FLIGHT CONTROLS - INSTALL MISSING CATERPILLAR GROMMETS IN THE BULKHEAD CUTOUTS

To install caterpillar grommets in the bulkhead cutouts to protect the elevator control cables.

CAL-27-06
Page 1 of 9

Figure 1. Cable Cutout Grommet Inspection//Replacement (Sheet 1)

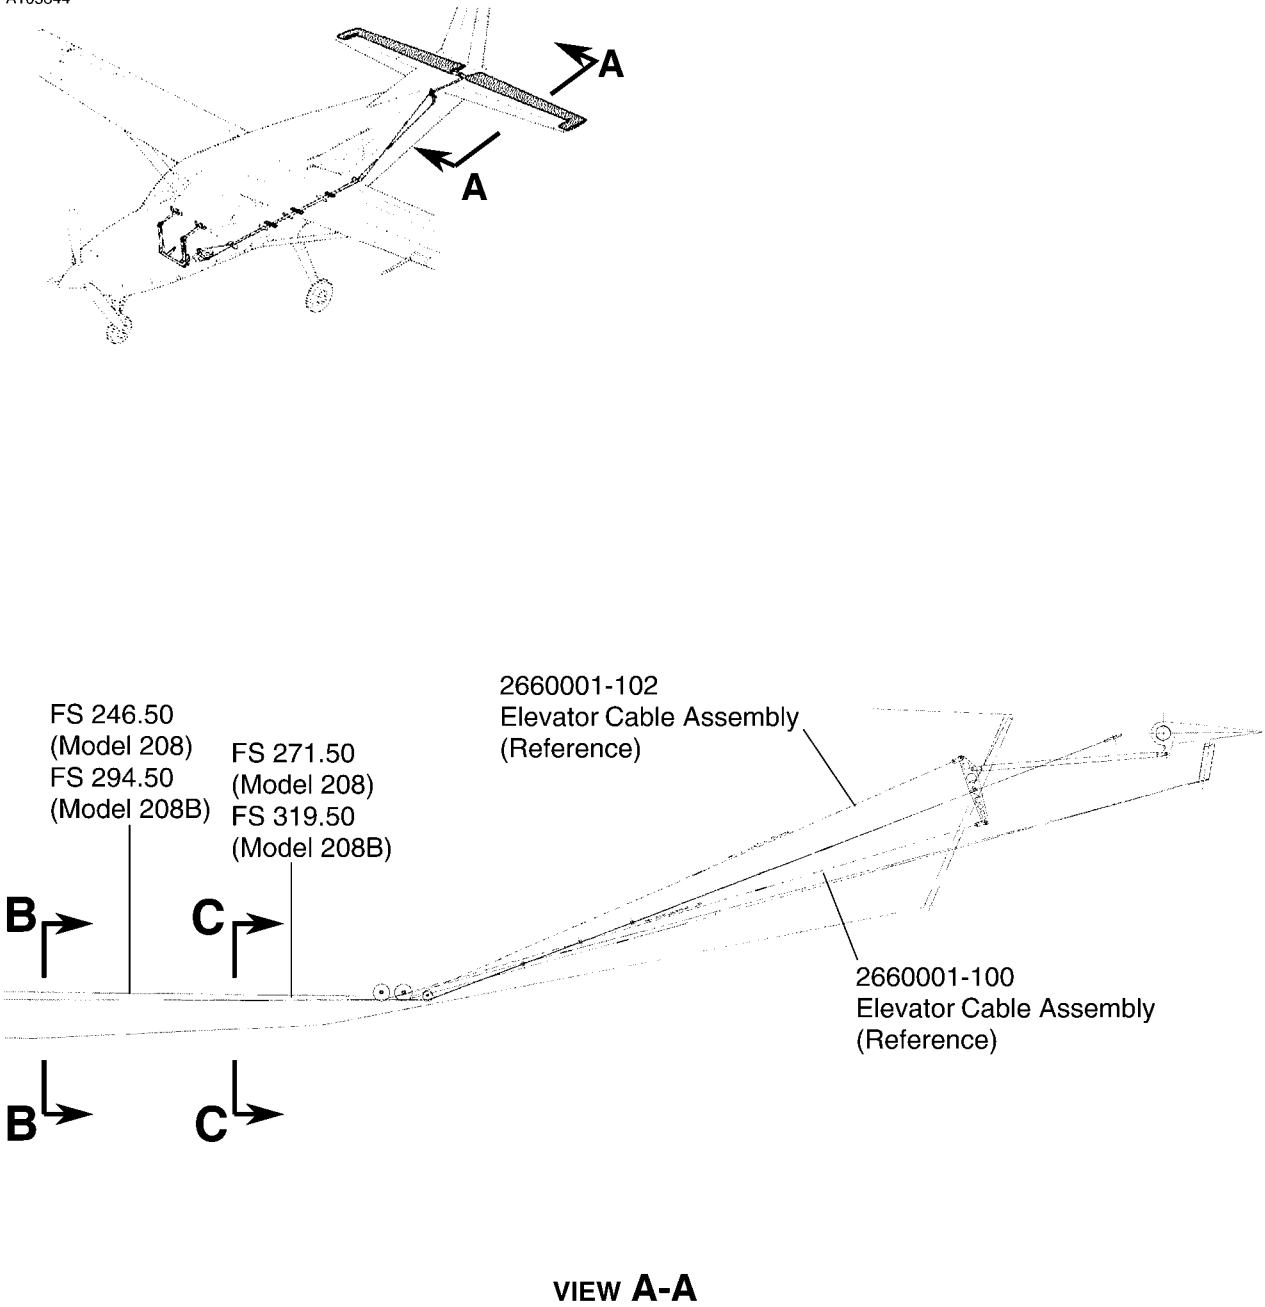
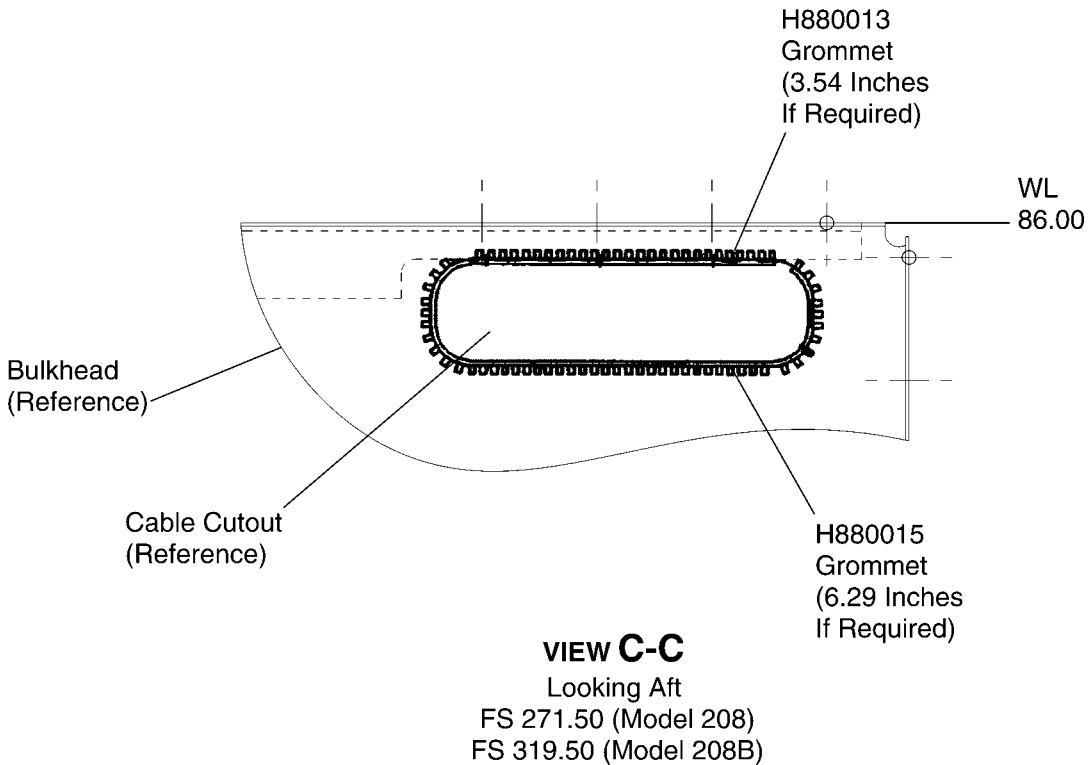
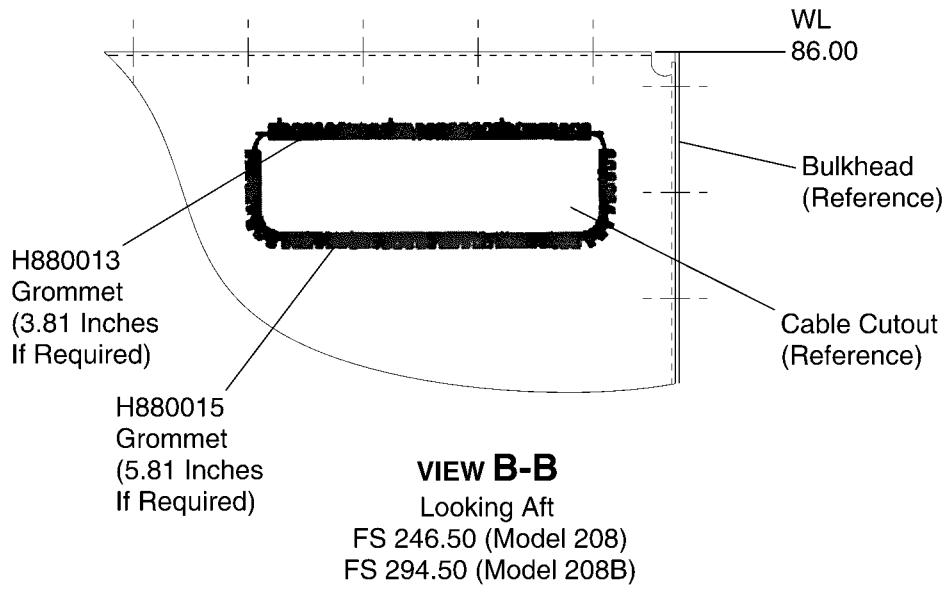
2. Inspect for the caterpillar grommets in the cable cutouts.
 - A. (Model 208) (Refer to Figure 1, View A-A, View B-B and View C-C.) Inspect for the caterpillar grommets at FS 246.50 and FS 271.50.

- (4) Inspect for the presence of caterpillar grommets
 - (a) If the caterpillar grommets are installed around the entire periphery of the cable cutout at FS 246.50 and FS 271.50 as shown, go to Step 2.A.(5).

- (b) If the caterpillar grommets are not installed around the entire periphery of the cable cutout as shown at either FS 246.50 and FS 271.50 do the steps that follow.

- B. (Model 208B) (Refer to Figure 1, View A-A, View B-B and View C-C.) Inspect for the caterpillar grommets at FS 294.50 and FS 319.50.
- (1) Remove passenger seats at FS 294.50 and FS 319.50 if installed. (Refer to the Model 208/208B Maintenance Manual, Chapter 25, Cabin Upholstery - Maintenance Practices.)

- (4) Inspect for the presence caterpillar grommets
 - (a) If the caterpillar grommets are installed around the entire periphery of the cable cutout at FS 294.50 and FS 319.50 as shown, go to Step 2.B(5).

- (b) If the caterpillar grommets are not installed around the entire periphery of the cable cutout as shown at either FS 294.50 and FS 319.50 as shown, do the steps that follow:

- 1 Install the grommets in the cable cutout at FS 246.50, if necessary.

- a Cut the H880015 Grommet to a length that will enable the grommet to go around the entire cutout.
- b Cut the H880013 Grommet to a length that will enable the grommet to go around the entire cutout.
- c Clean the cable cutout with Methyl n-Propyl Ketone. (Refer to the Model 208/208B Maintenance Manual, Chapter 20, Adhesive and Solvent Bonding - Maintenance Practices.)
- d Apply U000701 Adhesive to the mating surface of the applicable cable cutout and the grommets. (Refer to the Model 208/208B Maintenance Manual, Chapter 20, Adhesive Solvent Bonding - Maintenance Practices.)
- e Install the H880015 Grommet and H880013 Grommet in the cable cutout.
- f Clean any excess sealer squeeze out with Methyl n-Propyl Ketone.

- 2 Install the grommets at FS 271.50, if necessary.

- a Cut the H880015 Grommet to a length that will enable the grommet to go around the entire cutout.
- b Cut the H880013 Grommet to a length that will enable the grommet to go around the entire cutout.
- c Clean the cable cutout with Methyl n-Propyl Ketone. (Refer to the Model 208/208B Maintenance Manual, Chapter 20, Adhesive and Solvent Bonding - Maintenance Practices.)
- d Apply U000701 Adhesive to the mating surface of the applicable cable cutout and the grommets. (Refer to the Model 208/208B Maintenance Manual, Chapter 20, Adhesive Solvent Bonding - Maintenance Practices.)
- e Install the H880015 Grommet and H880013 Grommet in the cable cutout.
- f Clean any excess sealer squeeze out with Methyl n-Propyl Ketone.

- 1 Install the grommets in the cable cutout at FS 294.50, if necessary.

- a Cut the H880015 Grommet to a length that will enable the grommet to go around the entire cutout.
- b Cut the H880013 Grommet to a length that will enable the grommet to go around the entire cutout.
- c Clean the cable cutout with Methyl n-Propyl Ketone. (Refer to the Model 208/208B Maintenance Manual, Chapter 20, Adhesive and Solvent Bonding - Maintenance Practices.)
- d Apply U000701 Adhesive to the mating surface of the applicable cable cutout and the grommets. (Refer to the Model 208/208B Maintenance Manual, Chapter 20, Adhesive Solvent Bonding - Maintenance Practices.)
- e Install the H880015 Grommet and H880013 Grommet in the cable cutout.
- f Clean any excess sealer squeeze out with Methyl n-Propyl Ketone.

- 2 Install the grommets at FS 319.50, if necessary.

- a Cut the H880015 Grommet to a length that will enable the grommet to go around the entire cutout.
- b Cut the H880013 Grommet to a length that will enable the grommet to go around the entire cutout.
- c Clean the cable cutout with Methyl n-Propyl Ketone. (Refer to the Model 208/208B Maintenance Manual, Chapter 20, Adhesive and Solvent Bonding - Maintenance Practices.)
- d Apply U000701 Adhesive to the mating surface of the applicable cable cutout and the grommets. (Refer to the Model 208/208B Maintenance Manual, Chapter 20, Adhesive Solvent Bonding - Maintenance Practices.)
- e Install the H880015 Grommet and H880013 Grommet in the cable cutout.
- f Clean any excess sealer squeeze out with Methyl n-Propyl Ketone.
